**PROJECT NO. ES 2024-17 CITYWIDE LIFT STATION IMPROVEMENTS
CHEROKEE PARK LIFT STATION**

**ADDENDUM NO. 1
TO
PROJECT NO. ES 2024-17 CITYWIDE LIFT STATION IMPROVEMENTS
CHEROKEE PARK LIFT STATION**

**ADDENDUM NO. 1
APRIL 16, 2026**

**PROJECT NO. TMUA ES 2024-17
CITYWIDE LIFT STATION IMPROVEMENTS
CHEROKEE PARK LIFT STATION**

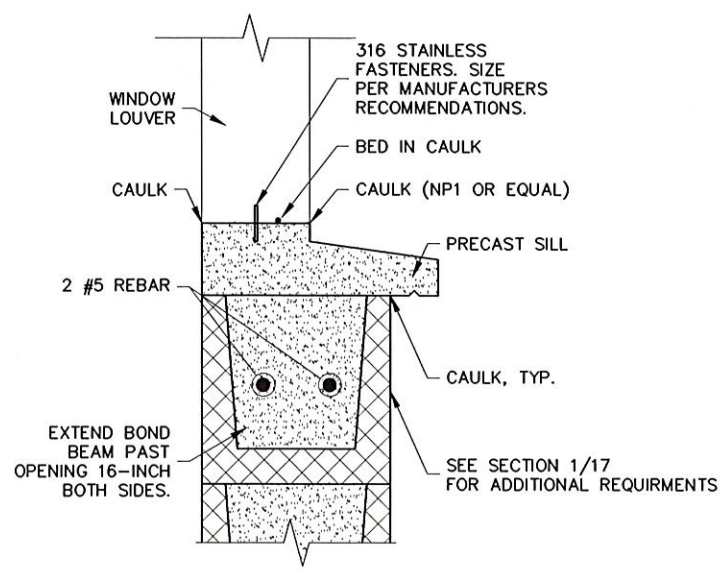
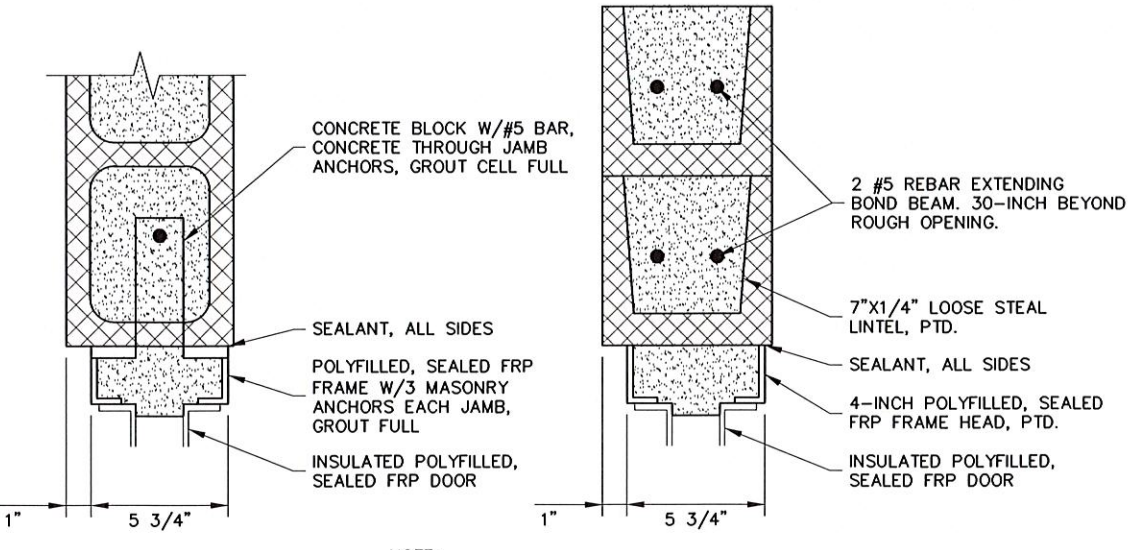
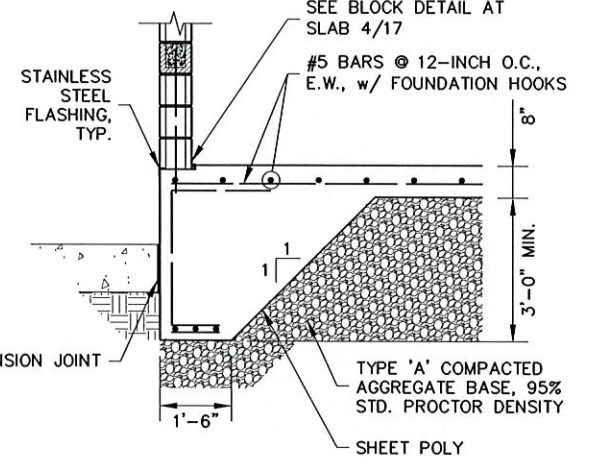
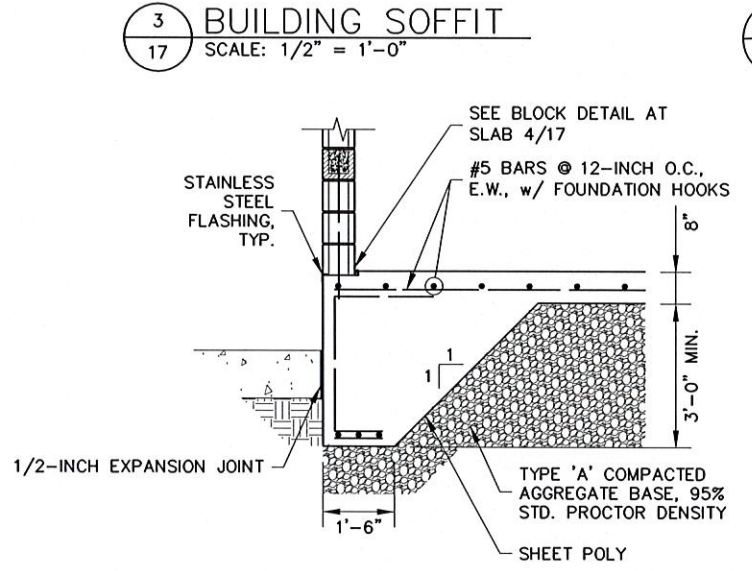
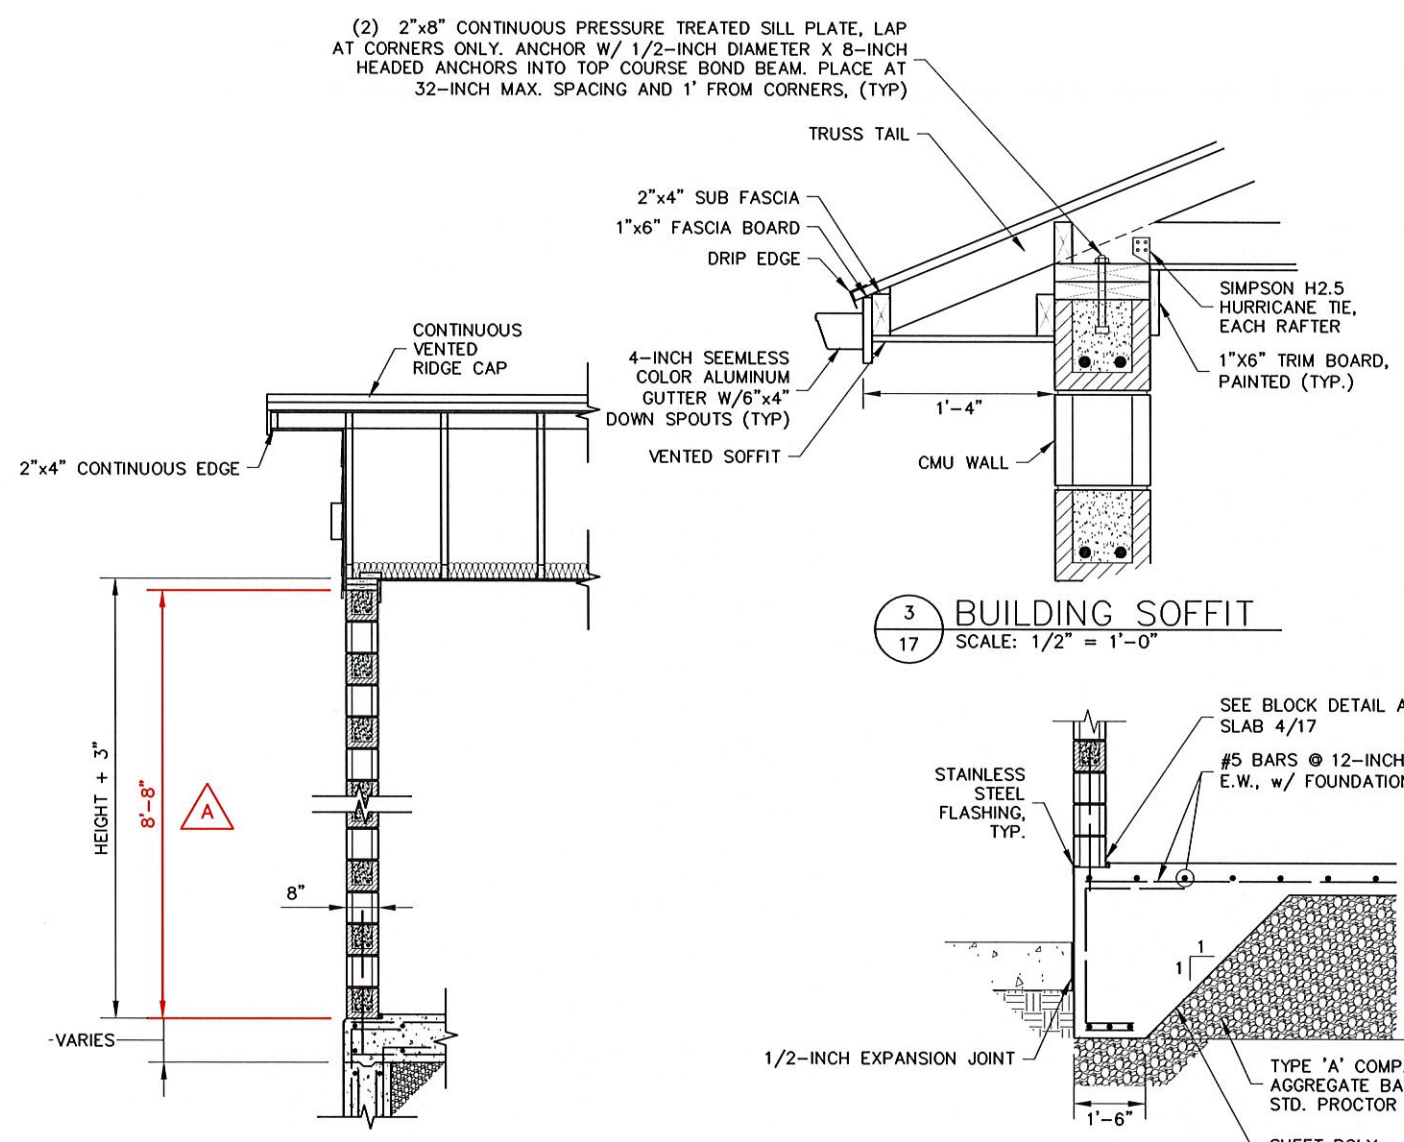
A 2. NOTE DELETED.
